SSD-9403

**1 and 2 Murray Rose
Avenue, Sydney Olympic
Park**

Section 4.55(1A) Modification
Report

Figure 4 Proposed Amendments – Basement Level 3

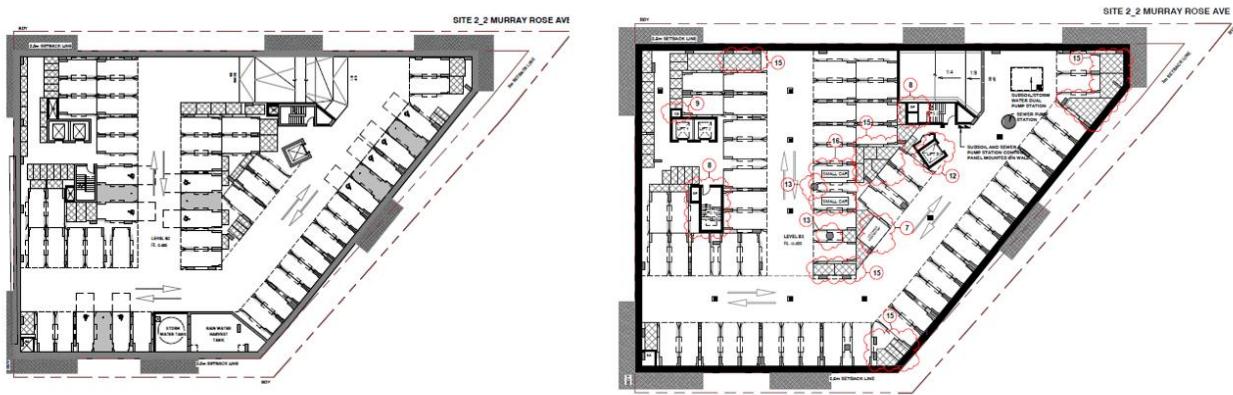
- Modification to the layout of car parking spaces
- Realignment of courtyard lift.
- Fire egress and core revised.
- Storage updated.
- Additional mirror.
- Serviced amended.
- Revised column location.

Figure 5 Proposed Amendments – Basement Level 2

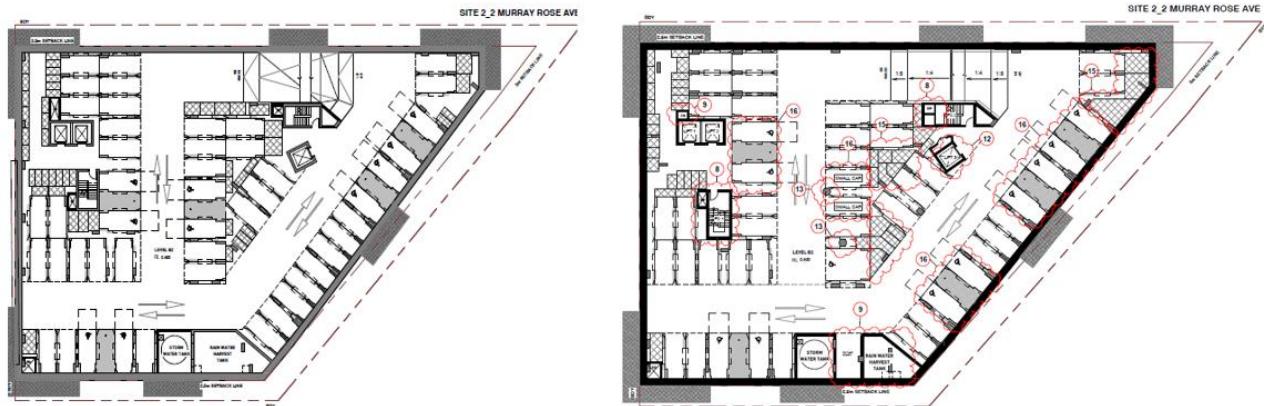
- Modification to the layout of car parking spaces including the removal of 2 standard spaces and the inclusion of an additional accessible space
- Provision of a rainwater pump and booster.
- Realignment of courtyard lift.
- Amended services, core configuration, column location, mirror location, storage layout.

Figure 8 Proposed Amendments – Level 1

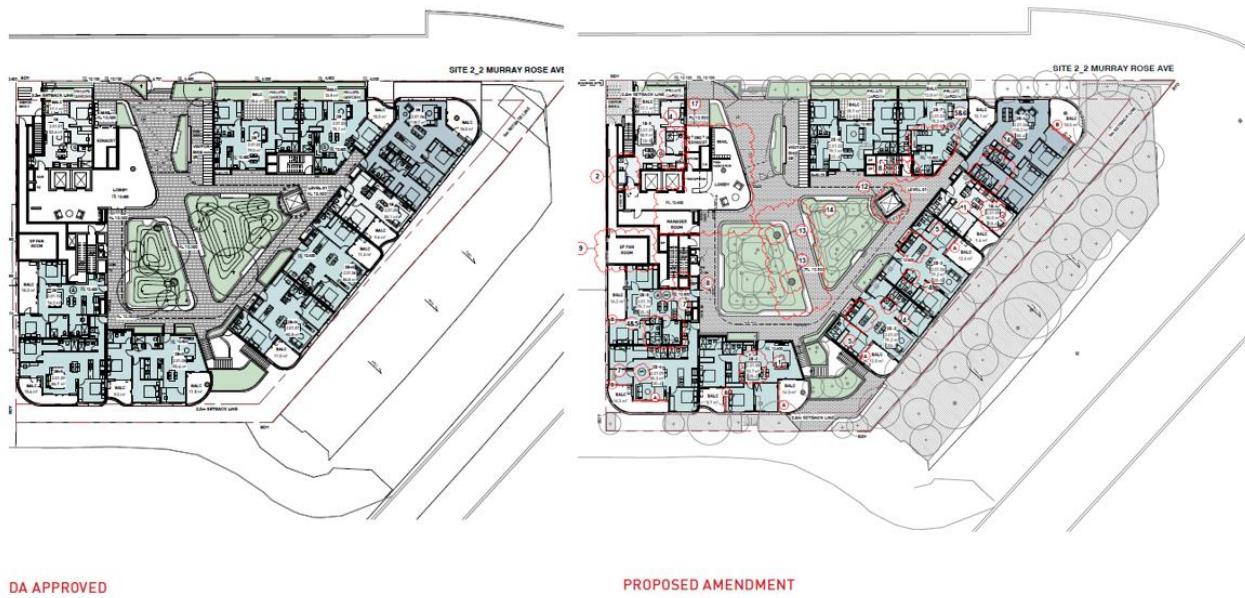
- Provision of a manager room within the space formally occupied by the southern area of the lobby
- Provision of a mail area within the space formally occupied by the northern area of the lobby
- Provision of a lobby desk
- Minor amendments to the layout of the plant space adjoining the lobby

Figure 9 Proposed Amendments – Level 8

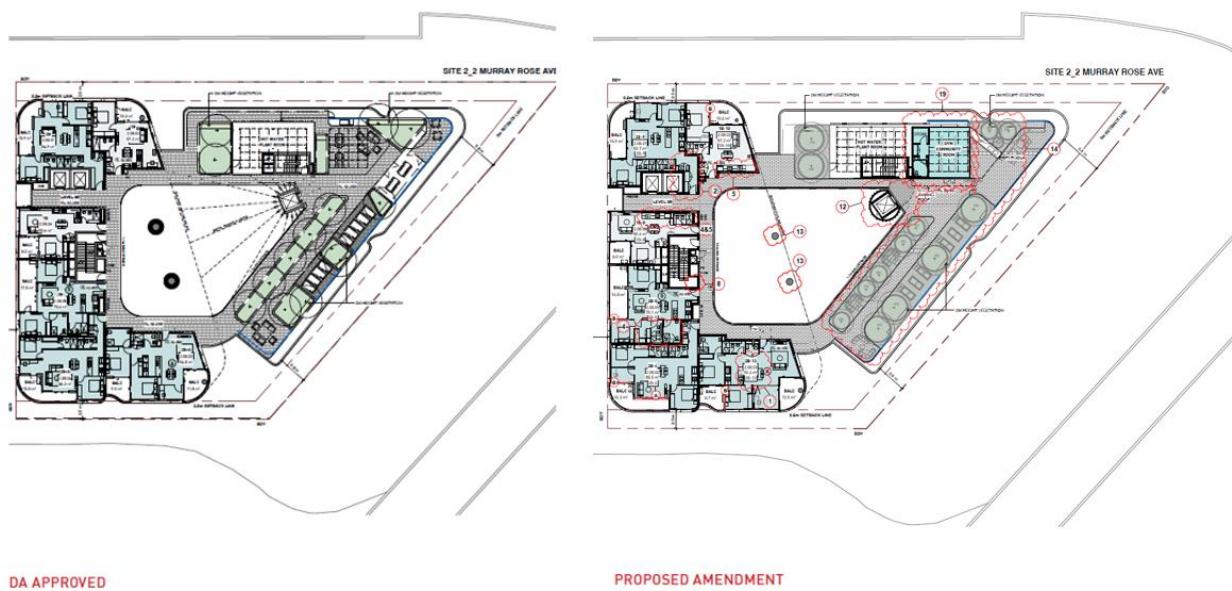
- Provision of a gym community room within the space formally occupied by rooftop seating
- Amendments to the rooftop landscaping along the eastern boundary of the rooftop

Figure 11 Proposed Amendments – Level 13

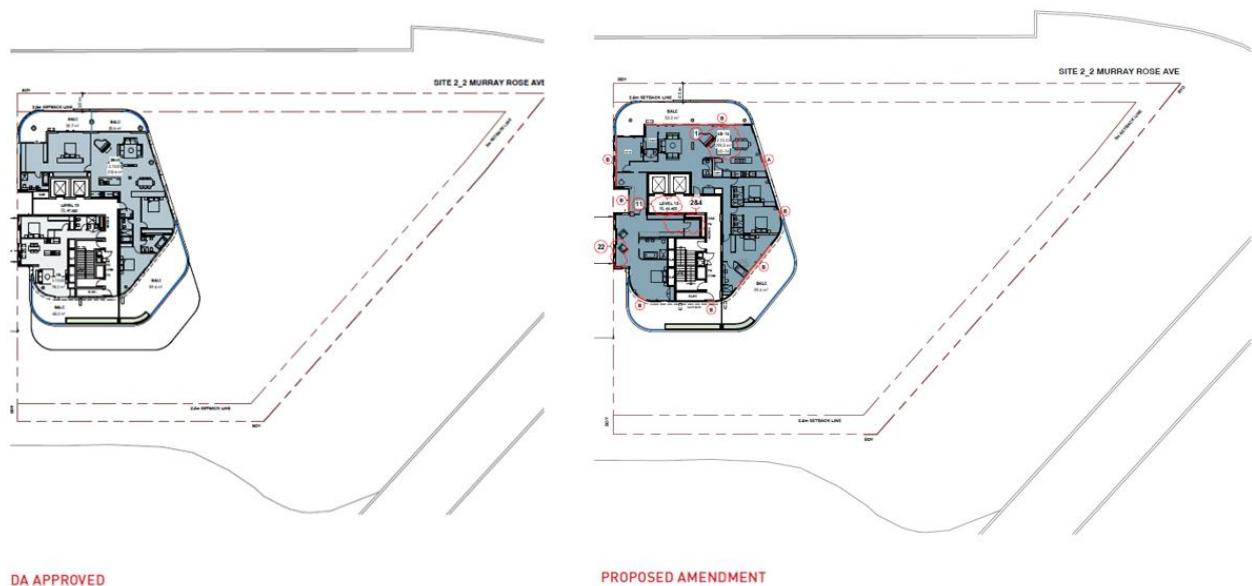
It is proposed to convert the existing 3-bedroom and 1-bedroom apartment at level 13 to a single 4-bedroom apartment (refer **Figure 11**).

Figure 12 Proposed Amendments – North and South Elevation

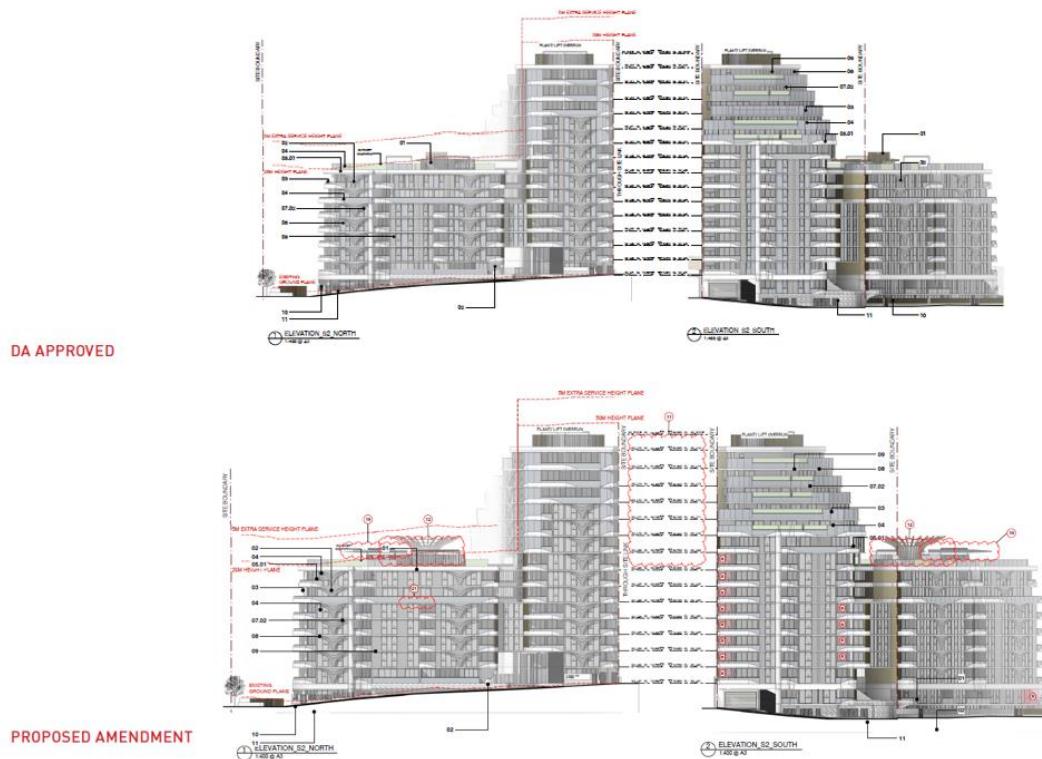
The proposal seeks structural changes to levels 9 - roof level including the thickening of concrete slab heights by at each level. Position of the Mega columns which provides support from basement to L09 (tower) has been revised to maintain structural alignment without significant transfers.

These amendments result height increase from RL 57.6 to RL 58.3 equating to a 0.7m overall increase in the building height (refer **Figure 12** and **Figure 13**).

Figure 15 Proposed Amendments – Rooftop

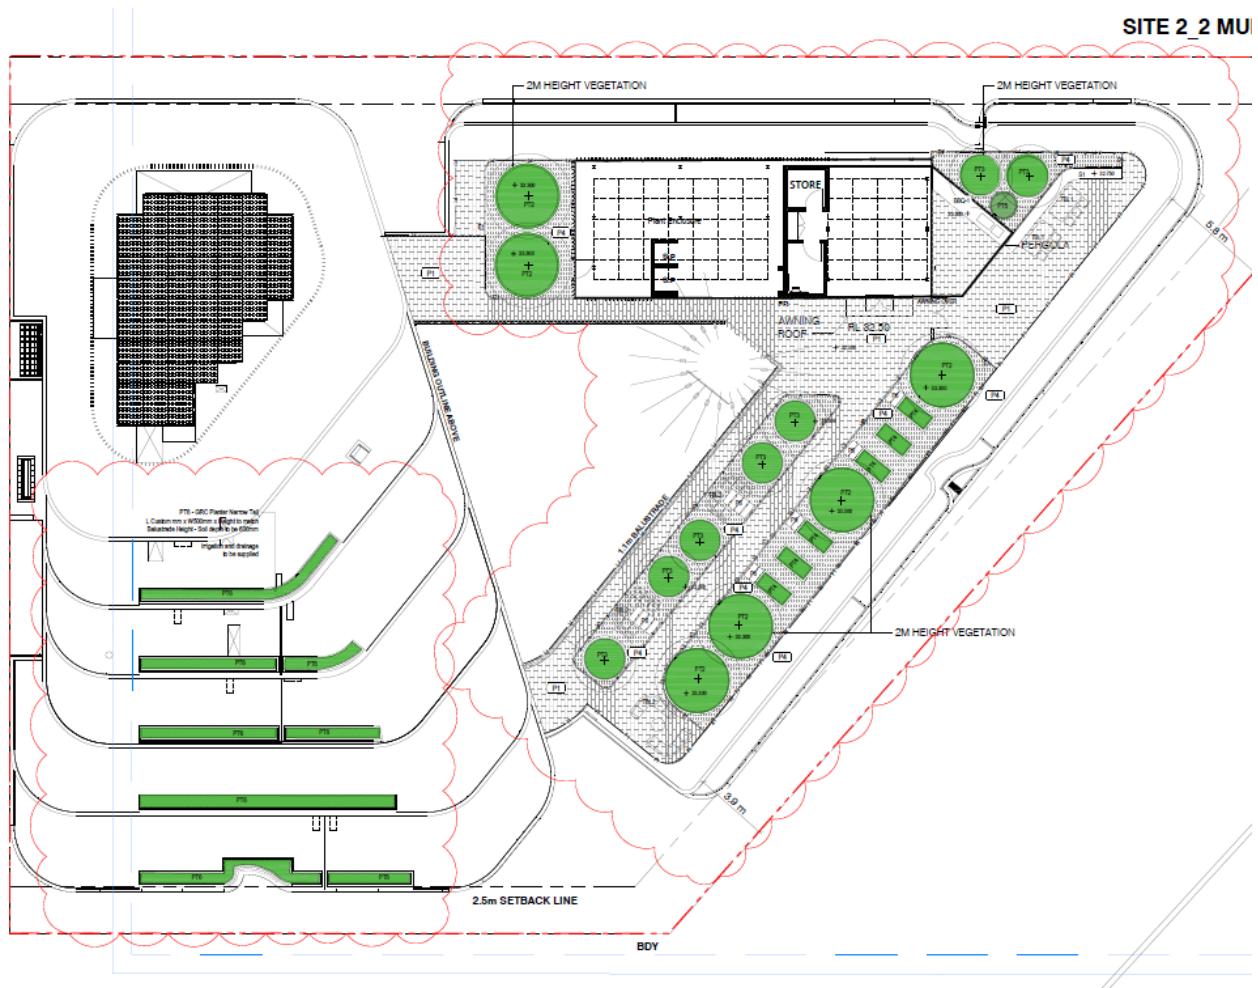
An amended set of landscape plans accompany the modification at **Appendix F**. Minor amendments are required to the landscaping strategy on the level 8 rooftop to reflect the provision of a gym community room within the space formally occupied by rooftop seating (refer **Figure 15**).

Figure 16 Height Control Analysis – Amended Proposal

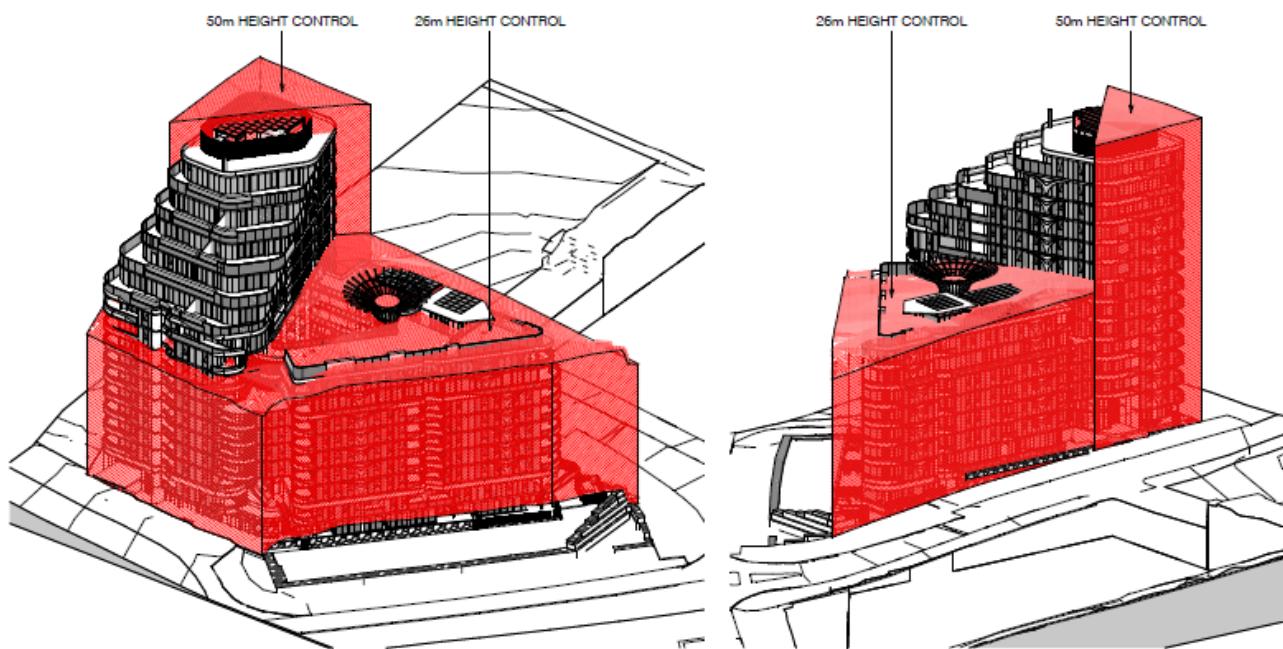
As detailed in the amended architectural plans at **Appendix D**, the proposal seeks structural changes to levels 9-roof including the thickening of concrete slab heights by at each level which results in a 0.7m overall increase in the building height. This results in an overall building height of 58.3m. **Figure 16** provides a height control analysis of the amended proposal.

Figure 17 Additional Overshadowing – 21 June - Afternoon

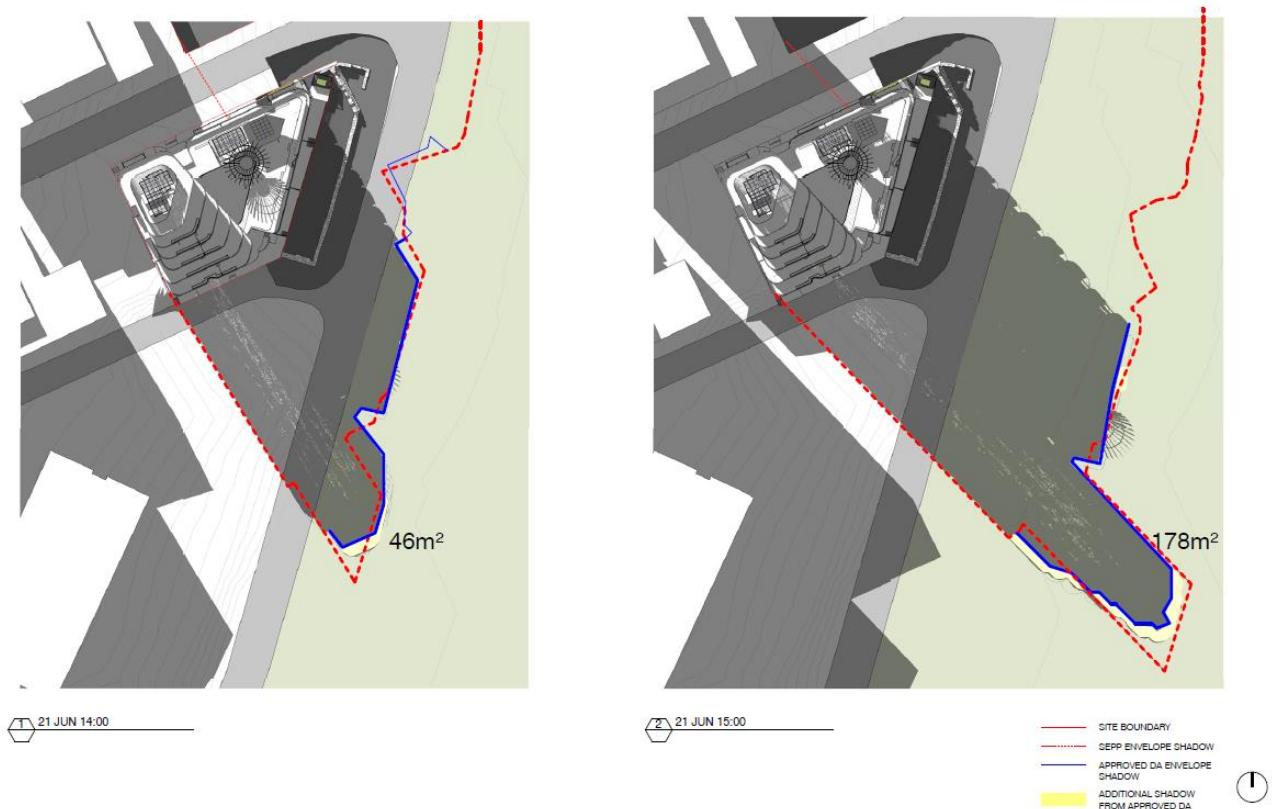
As detailed in **Figure 17** below, the minor increase in height proposed results in additional overshadowing during mid-winter (21 June) at 2pm and 3pm. Notwithstanding this, the majority of this 46m² increase (2pm) and 178m² increase (3pm) sits within the SEPP shadow envelope, with some minor exceedance outside the envelope.
